## MEMORANDUM FOR RECORD

SUBJECT: Ohio River Mainstem Systems Study Filling/Emptying Hydraulic Model

1. An in-progress review meeting of the filling and emptying model for the Ohio River Mainstem Systems Study (ORMSS) was held at Vicksburg, MS on 13-14 March, 2000. A list of attendees is provided below.

FIGURE 1.

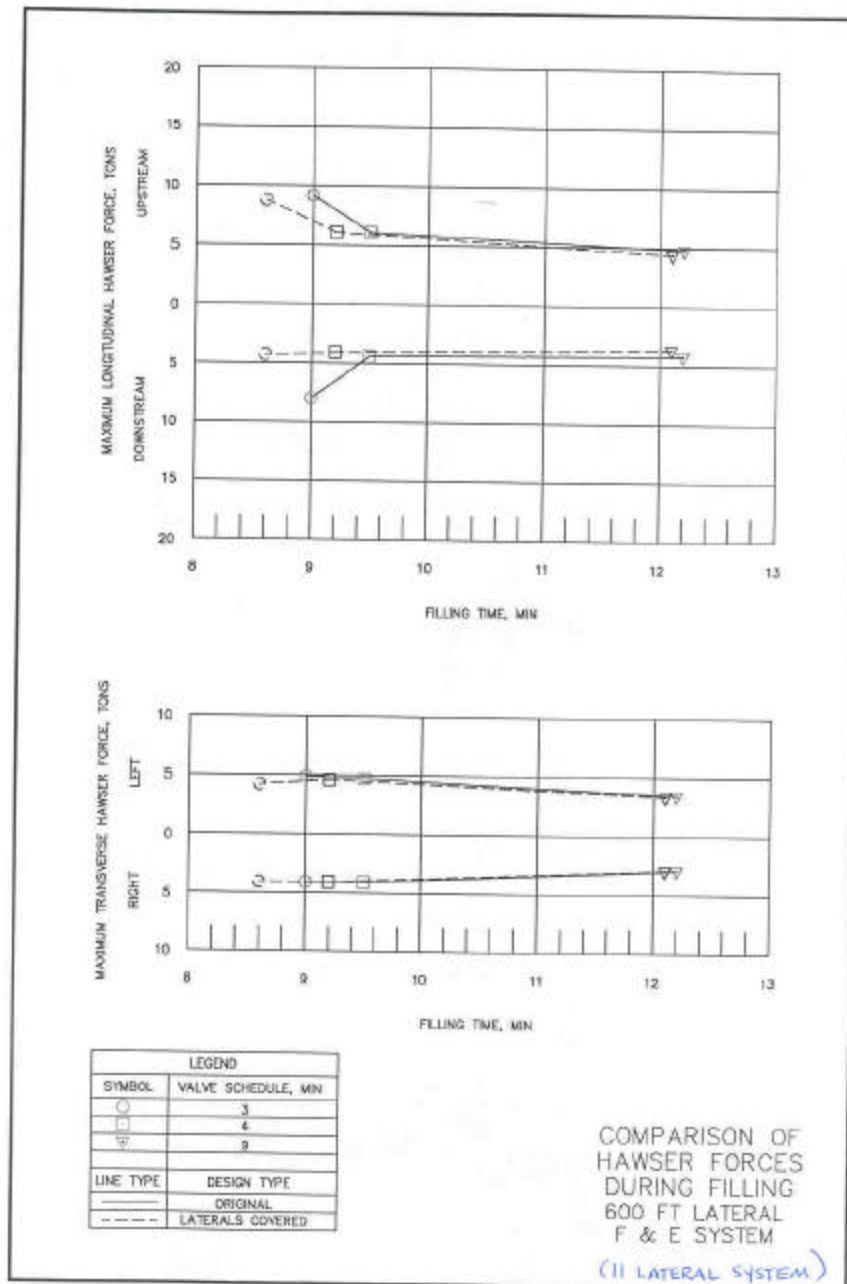
The tests investigated filling and emptying times for valve operations at 3, 4, and 9 minutes both with and without the existing laterals partially covered. Figures 1 through 4 in the back of this memorandum show the results of the tests. Figure 1 depicts the filling time for a 600-ft chamber (on the horizontal axis) versus the hawser force in tons along the vertical axis. These tests were run with a representative 35-ft head. This represents the high end of the operating head ranges on the Ohio River. Greenup generally operates with a nominal 30-ft head. As evidenced by Figure 1, the maximum hawser force occurs in the upstream, longitudinal direction for a valve operation time of 3 minutes. Present guidance calls for a maximum hawser force of 5 tons. Using the upstream, longitudinal hawser force as the limiting case, the hawser force drops below 5 tons at approximately 11.6 minutes for the existing condition where the laterals are NOT partially covered. With the laterals partially covered, the filling time for a 5-ton hawser force actually drops to about 11.2 minutes.

- \* GREENUP PRESENTLY FILLING AUX. CHAMBER AROUND 8 1/2 TO 9 MINUTES, BUT OPERATING HEAD IS USUALLY 30-FT, NOT 35-FT HEAD

FIGURE 2.

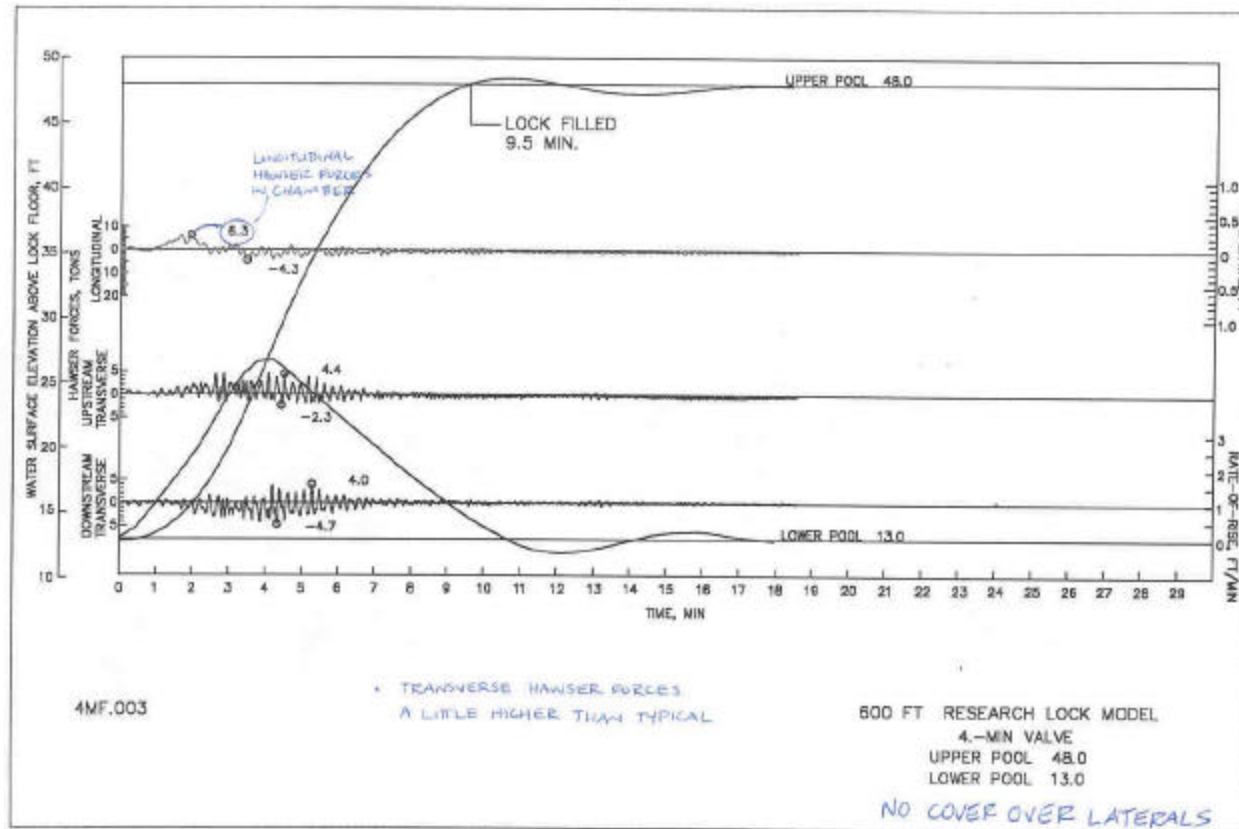
Figures 2 and 3 show the time history lock chamber filling curves for a 4-minute valve operation with and without the laterals partially covered, respectively. As you can see, the maximum hawser force remains unchanged at 6.3 tons for both cases. However, the filling time for the case with the laterals partially covered is actually reduced from 9.5 minutes to 9.3 minutes when compared to the non-covered case (Figure 2).

• INSTALLED GATE AT 670' LENGTH  
TO REPLICATE AUX. CHAMBER

• NO COVER OVER LATERALS

• MODIFICATIONS TO EXISTING F/E  
MODEL RESULTS (5 TONS PRESENT ALLOWABLE)

FIGURE 3.

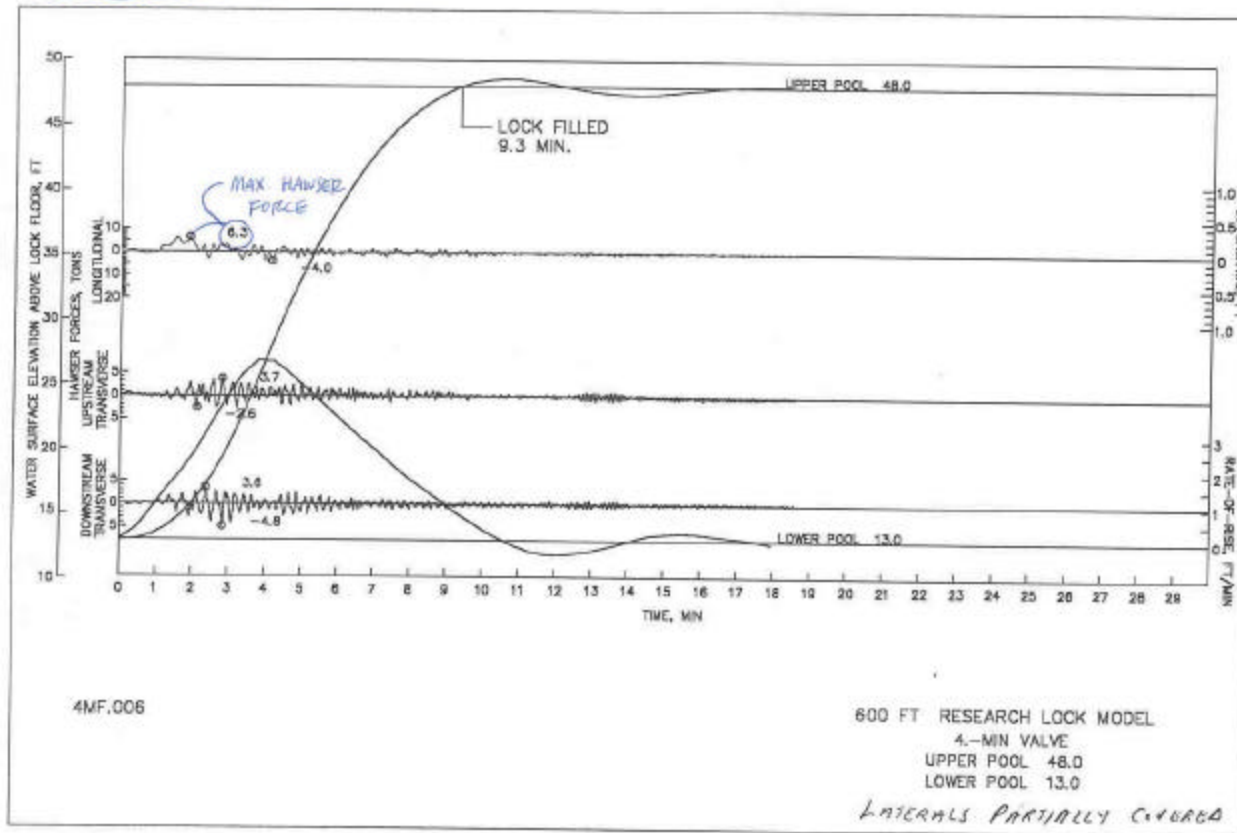
• WE HAVE NOT HURT THE HAMSER FORCES BY PARTIALLY COVERING THE TOPS OF THE LATERALS.

• COVERING REPRESENTED BY 29-FT CULVERTS AGAINST THE SIDES.

FIGURE 4.

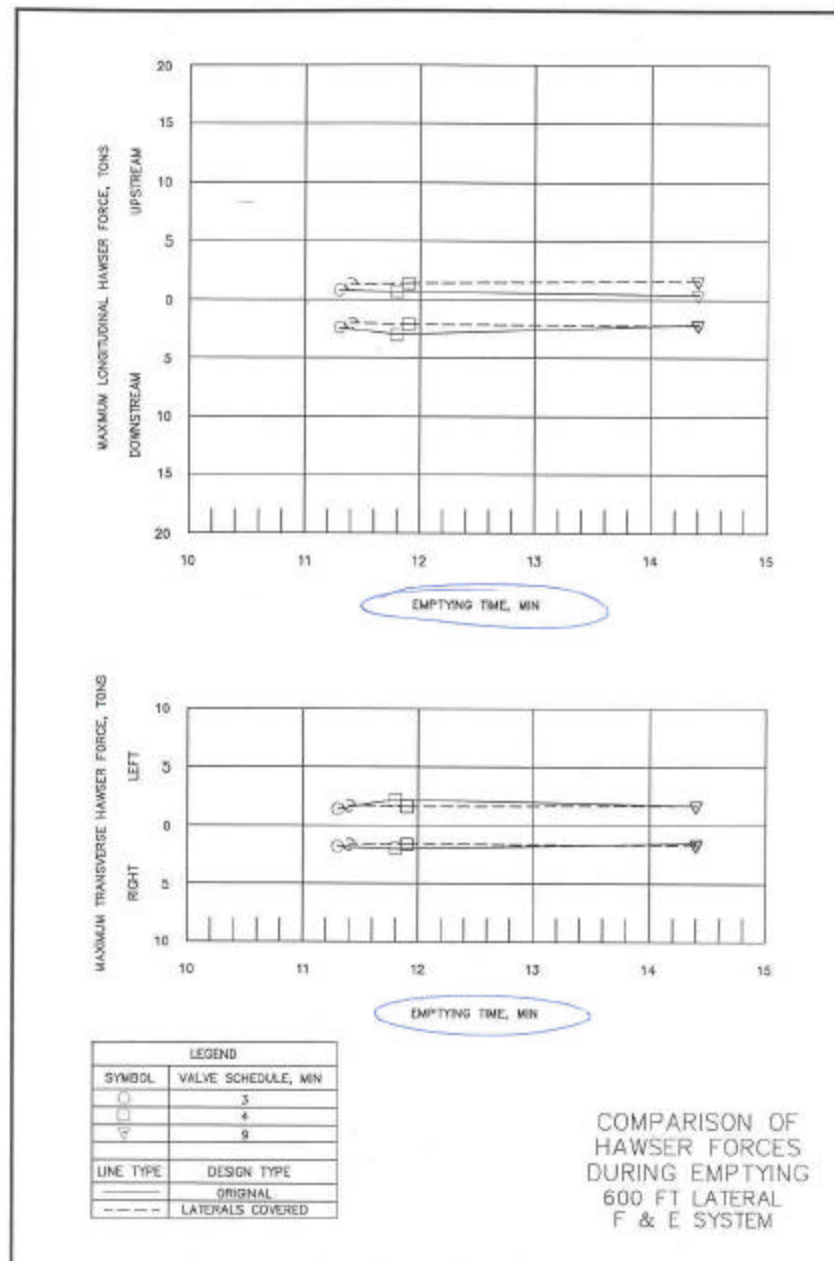
Finally, Figure 4 depicts the emptying times for the same series of valve operations. As is typically the case, emptying hawser forces do not control the processing time as all forces fall below the 5-ton limit. Both cases, the with laterals partially covered and the existing condition, generally provide the same emptying performance.
